Product Change Notice (PCN)

PCN Number: **PCN-0456185R-01**

Product(s) Affected: **SJ-435107 & SJ-435107RS**

<p data-bbox="292 1669 519 1701">Recommended PCB Layout Top View</p>	 <p data-bbox="925 1669 1136 1701">Recommended PCB Layout Top View</p>

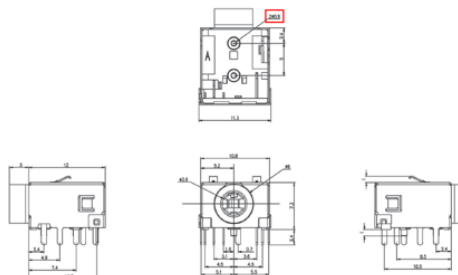
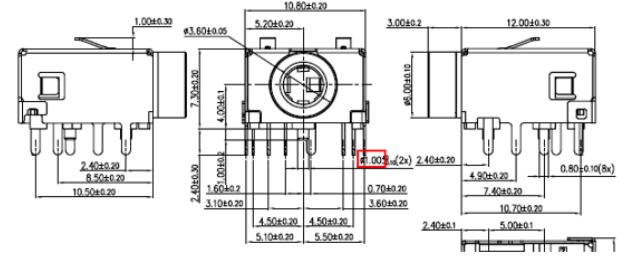
Description of Change: *New Factory Location. Product re-engineered for improved manufacturability and production yield. See image below for reference and check the Same Sky website for updated drawing after 10/20/2024. Cosmetic differences may be visible but will not affect the form fit and function of the product.*

PREVIOUS SAME SKY DETAIL / IMAGE			NEW SAME SKY DETAIL / IMAGE		
DESCRIPTION	MATERIAL	PLATING/COLOR	DESCRIPTION	MATERIAL	PLATING/COLOR
terminal (1-6)	copper alloy	tin	terminal (1-6)	copper alloy	tin
shield	copper alloy	nickel	shield	brass	nickel
bushing	brass	nickel	bushing	brass	nickel
housing	PA66 (UL94V-0)	black	housing	PA66 (UL94V-0)	black
